ADDENDUM NO. SEVEN

October 8, 2024

Lamont Park Beautification Project

1650.7012.22

JOB	LI.02
CD	
FW - MM - AD	
20 OF 36

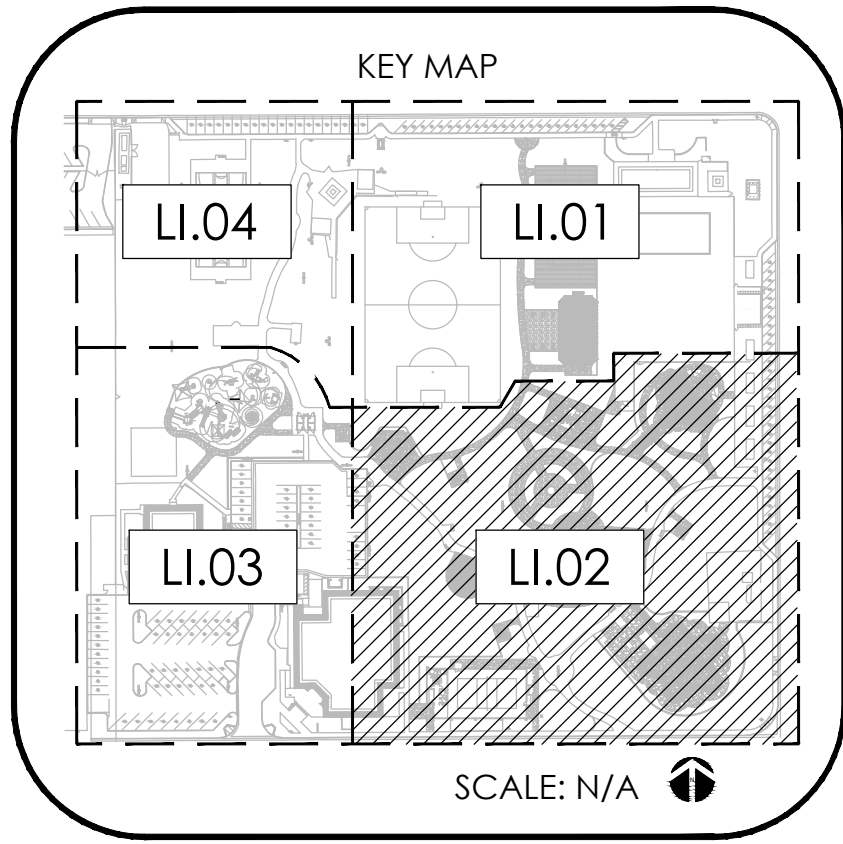
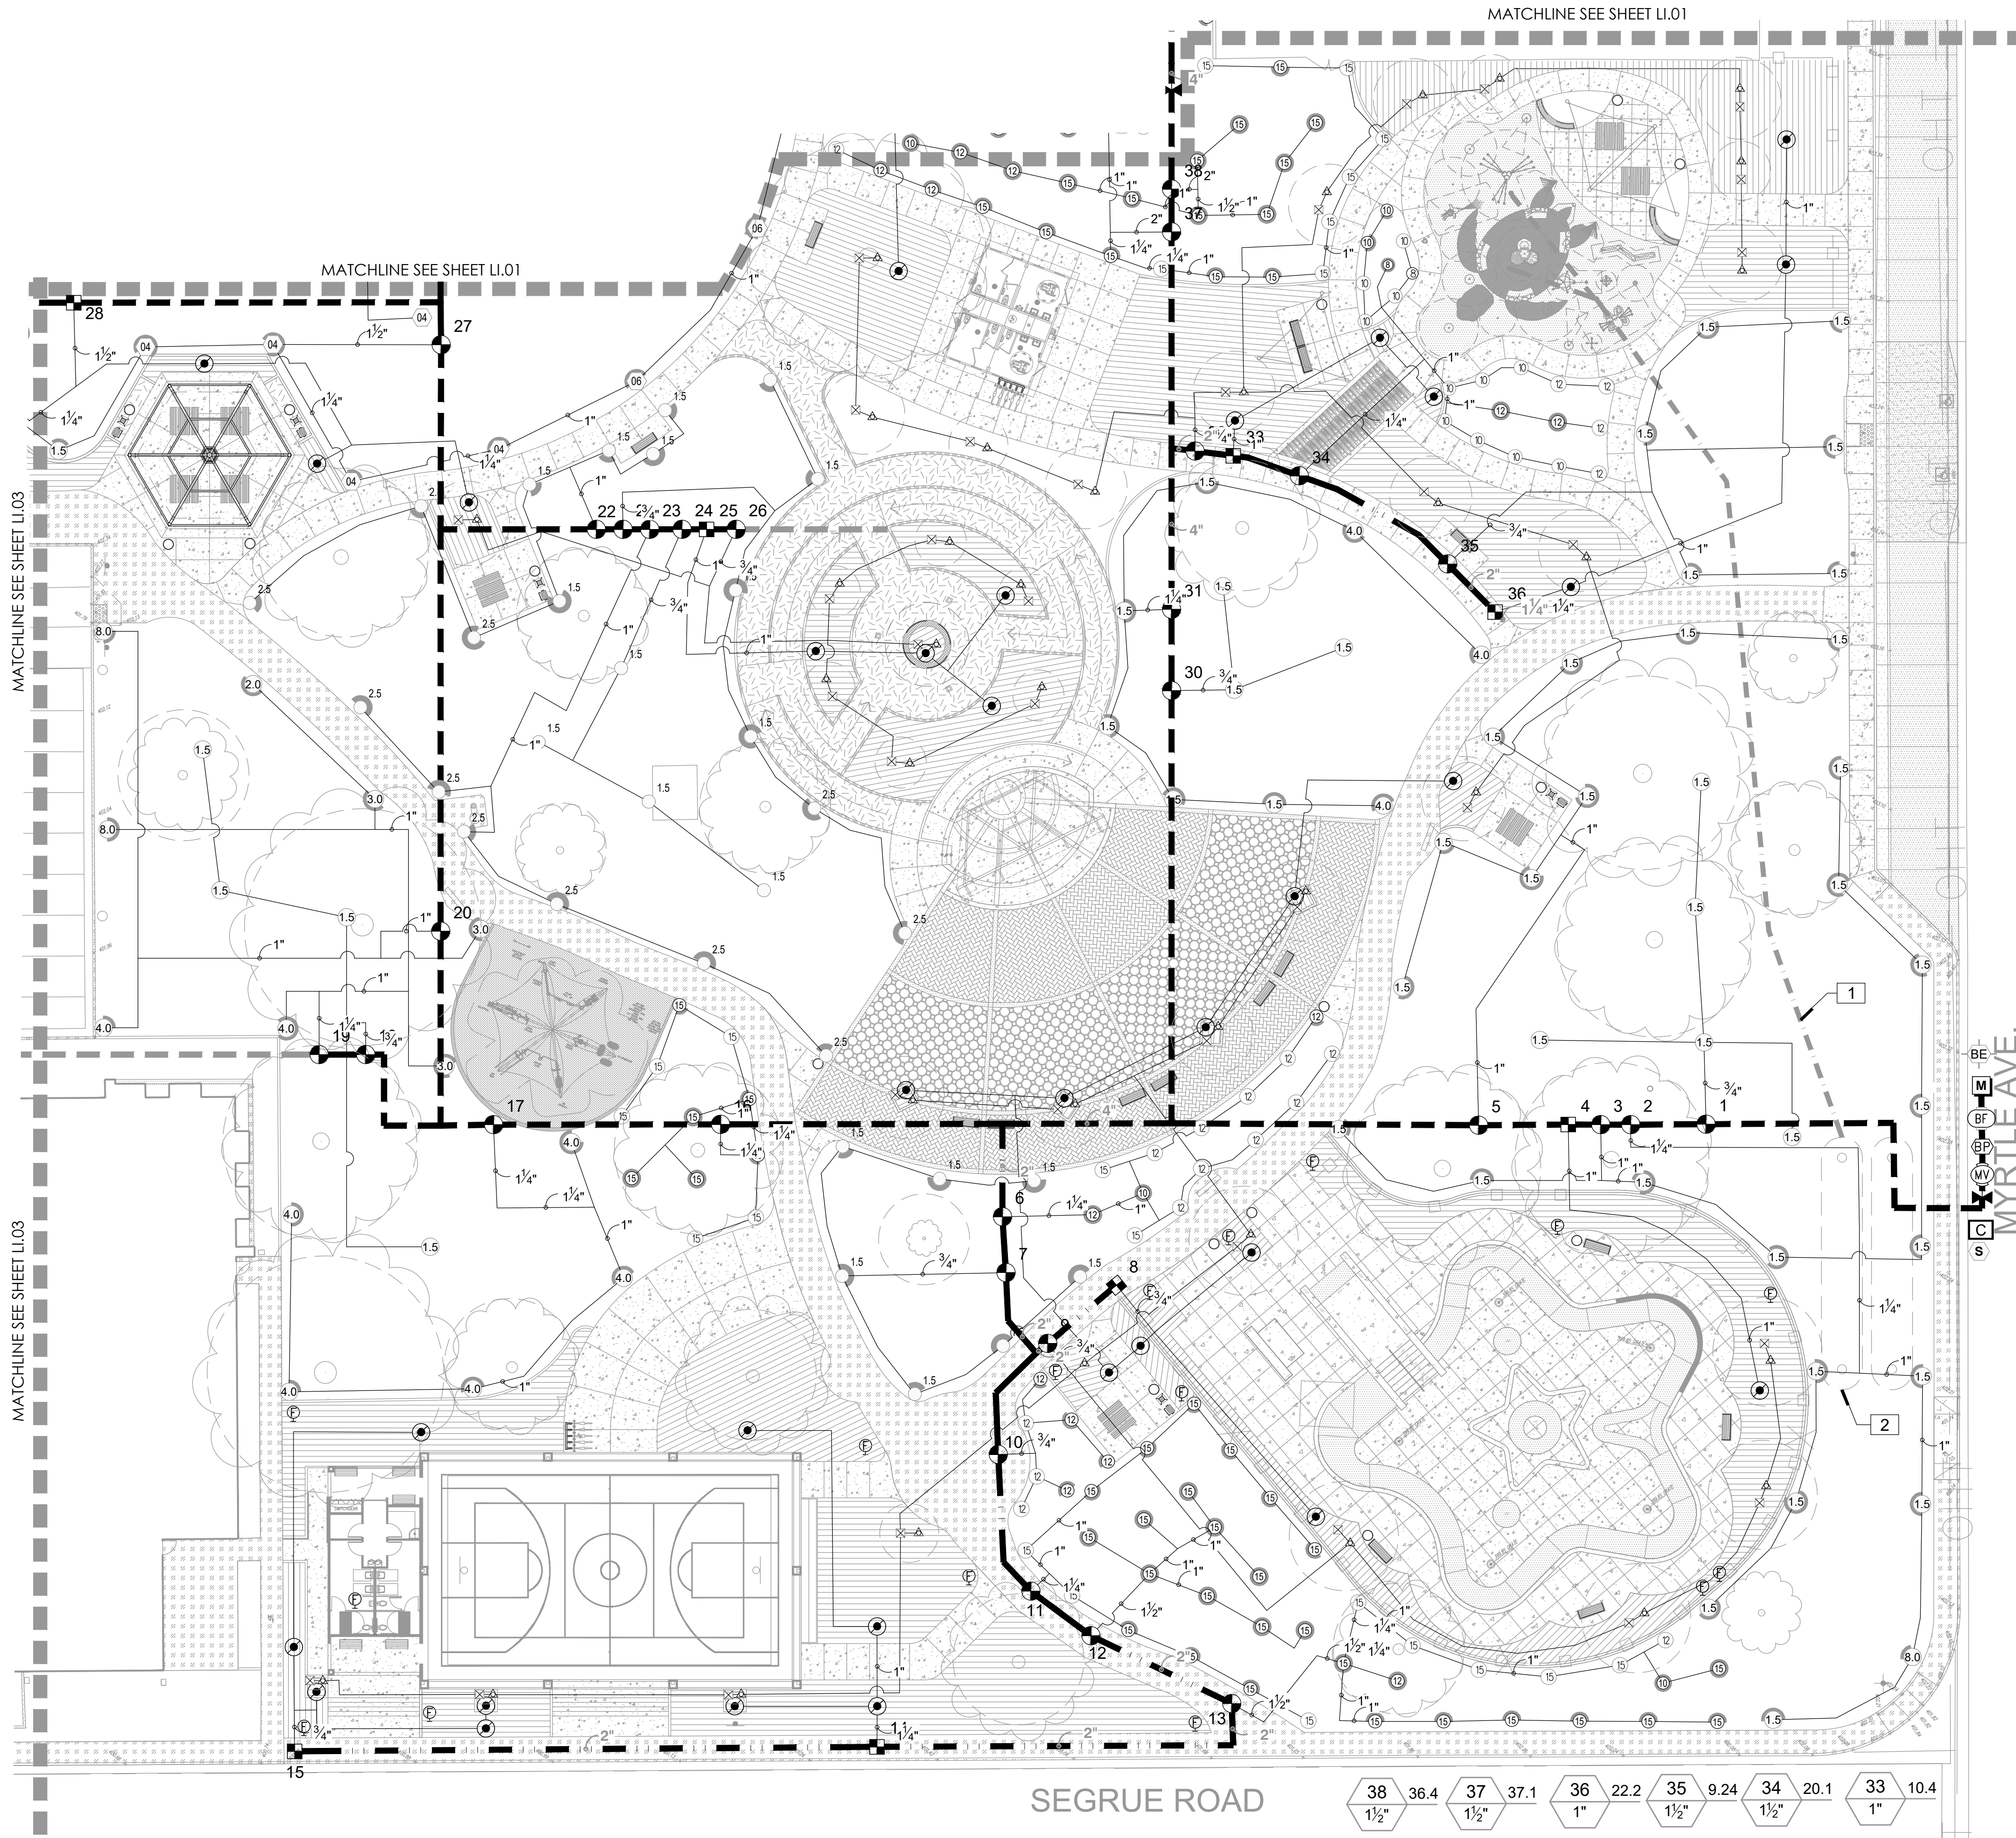
- Item No. 9:** Refer to attached sheet LI.02 and replace existing sheet LI.02 in its entirety.
- Item No. 10:** Refer to attached sheets LCD.04 and LCD.07 and replace existing sheet LCD.04 and LCD.07 in their entirety. Refer to revision clouds for modifications.
